**City of Lincoln
Planning**

Nebraska Capitol Environs Commission
Agenda

re: Agenda of November 20, 2008

KAPLAN / LINCOLN
VALUE ENGINEERING REVISIONS
10.22.08

8.001

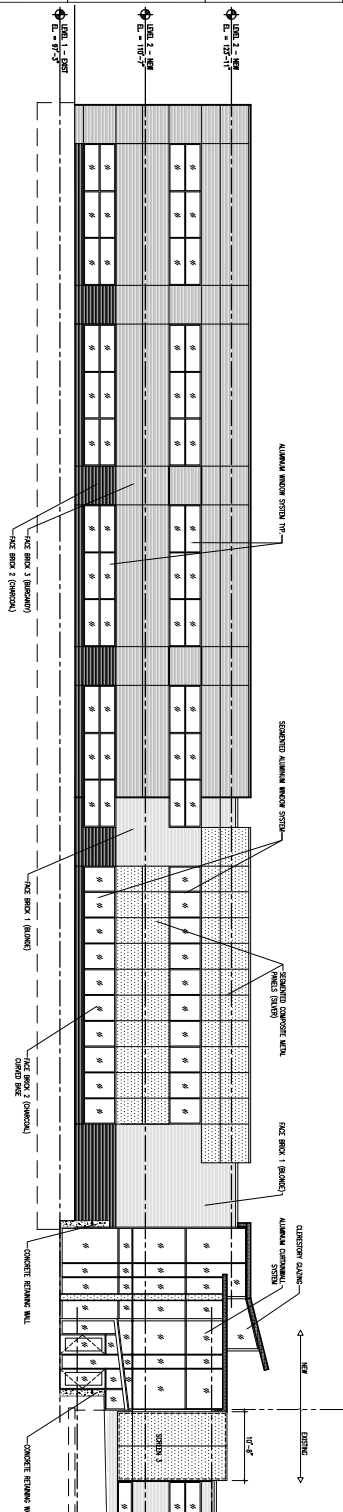
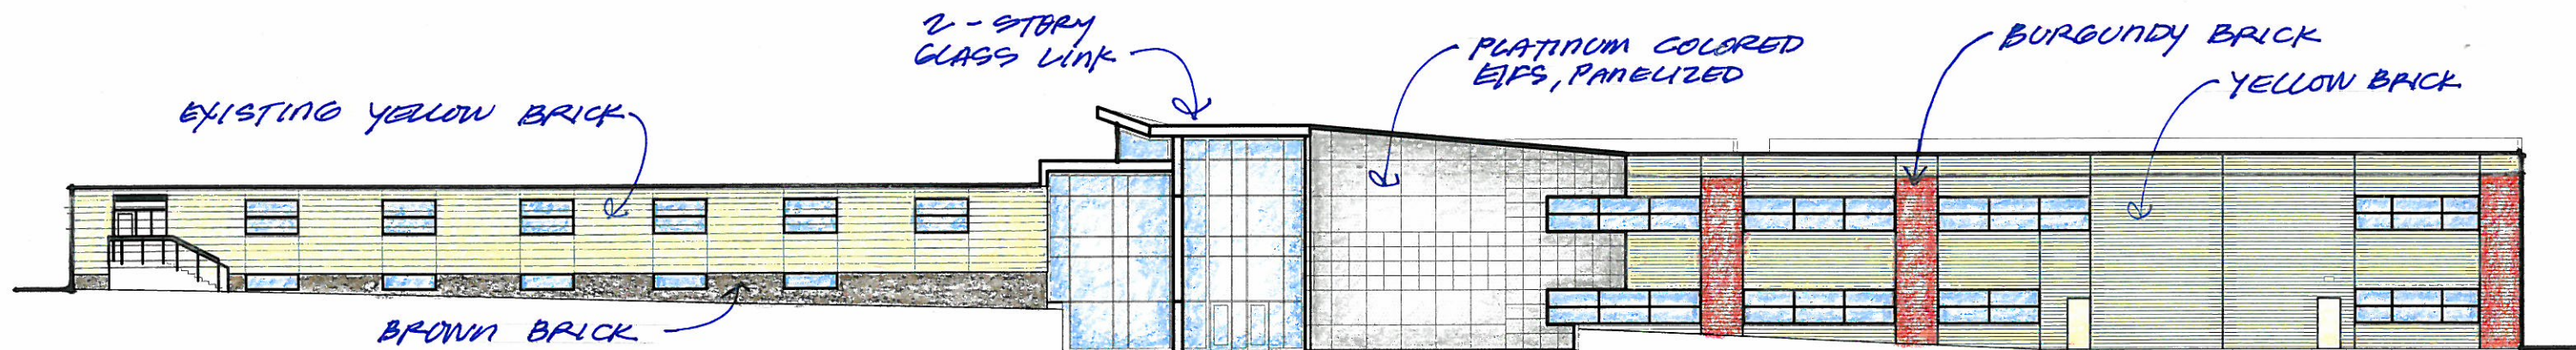
2. Kaplan proposes a substitution of “Platinum Colored EIFS, Panelized” for the architectural metal panels approved at the west end of the new addition. On the north (K St.) elevation, this portion of the building is a curved wall, intended as a focal point at the south terminus of the new 19th St./Antelope Valley Parkway. At that location, the EFIS is proposed in bands between the first and second story windows and above the upper windows. On the south side, the EFIS would be adjacent to the parking lot entrance, from grade level to parapet.

The Kaplan property has been zoned O-1 and hence is subject both to the Environs District Standards and to the recently adopted Downtown Design Standards. Synthetic stuccoes such as EFIS are permitted by those standards, above twelve feet in height. The elevation drawings are not dimensioned but the north facade appears to meet at least the intention of this standard by keeping less-durable materials out of harm's way.

The south facade is far less visible to passersby but will presumably provide a major entrance from the new parking area. Using a more durable material for at least the lower portion of this area would be preferable. The Commission should determine whether this south elevation is a street facade and whether strict conformance with the Downtown Design Standards in this detail is required.

- The landscape plan for the south parking lot appears to conform with the Environs Design Standards.
- The substitution of EFIS at the focal point of the north facade is regrettable but probably meets the Environs and Downtown Design Standards in this location.
- The south facade, set back a considerable distance from J Street, probably should not be regarded as a street facade under the Downtown Standards

- and has little impact on the Capitol setting under the Environs Standards. The Commission should determine whether to “contribute to the overall quality of the District,” a more durable alternative to EFIS should be used on the south facade at ground level, adjacent to an entrance.
